DECISION OF THE HISTORIC LANDMARKS COMMISSION

CLASS 3 MAJOR HISTORIC DESIGN REVIEW CASE NO.: HIS24-03

SUMMARY: A proposal to construct a new street-facing granite wall and rehabilitate the exterior of the 460 Bush Street SE house (c.1920).

DECISION OF THE SALEM HISTORIC LANDMARKS COMMISSION

RETAINING WALL DETAIL

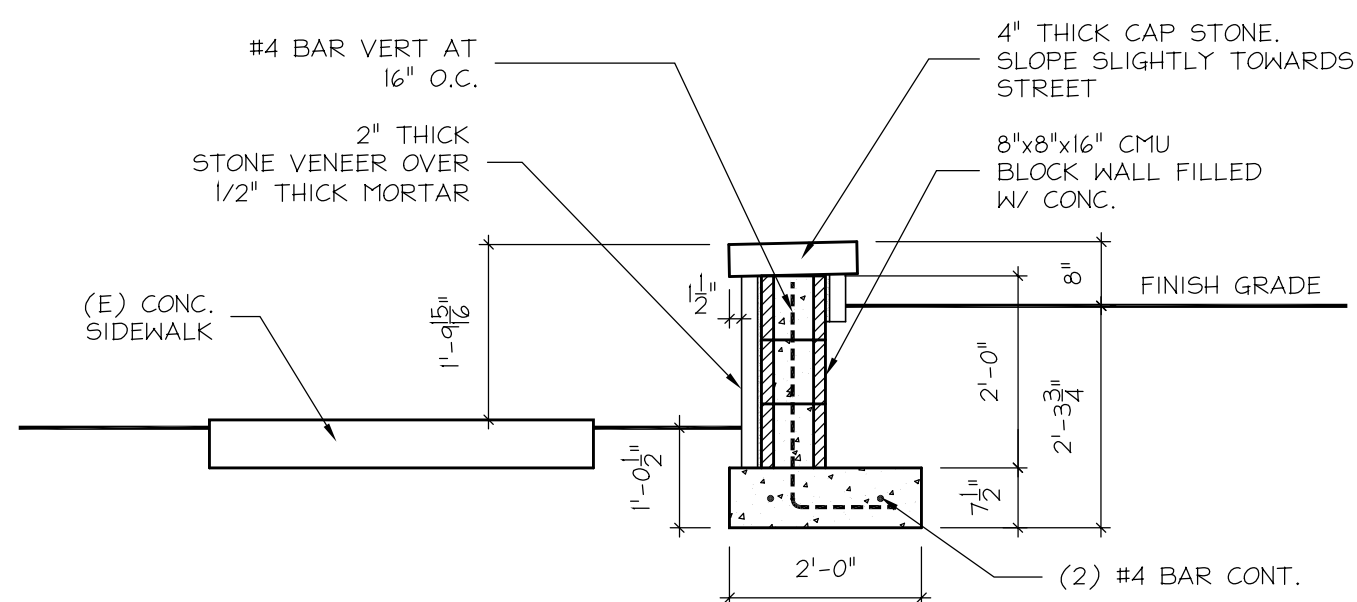
The HLC finds that the partially constructed stone retaining wall will require engineered design and building permits and if found to be in the public right-of-way must obtain a revokable encroachment permit per SRC 76.160 prior to resumption of work. Therefore, the HLC adopts the following Condition of Approval to ensure with permitting and Public Works standards:

Condition 2: The applicant shall obtain a Public Works revokable encroachment permit per SRC 76.160 if necessary prior to the issuance of any City permits authorizing work on the property.

COLUMN DETAIL

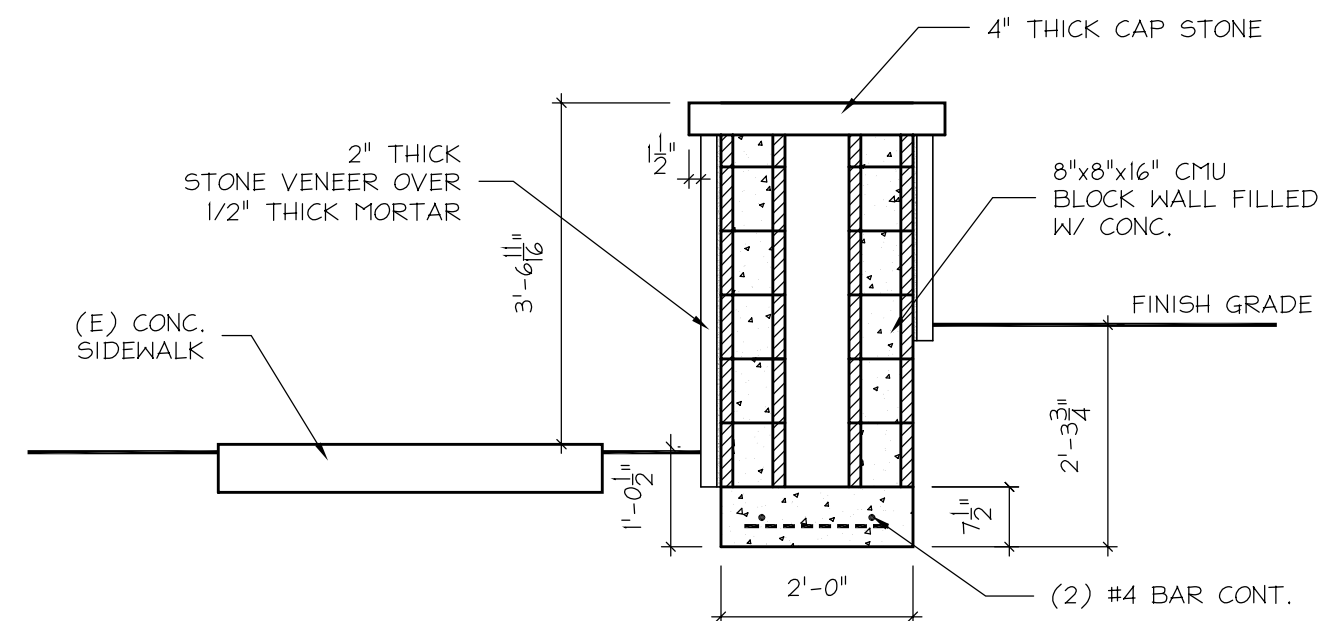
The HLC finds that per SRC 800.055(a)(1)(A)(i) the wall columns must be limited to 30" in height. Therefore the HLC adopts a Condition of Approval to ensure compliance prior to resumption of construction:

Condition 1: The applicant shall modify the retaining wall design so that columns are no more than 30" in height.
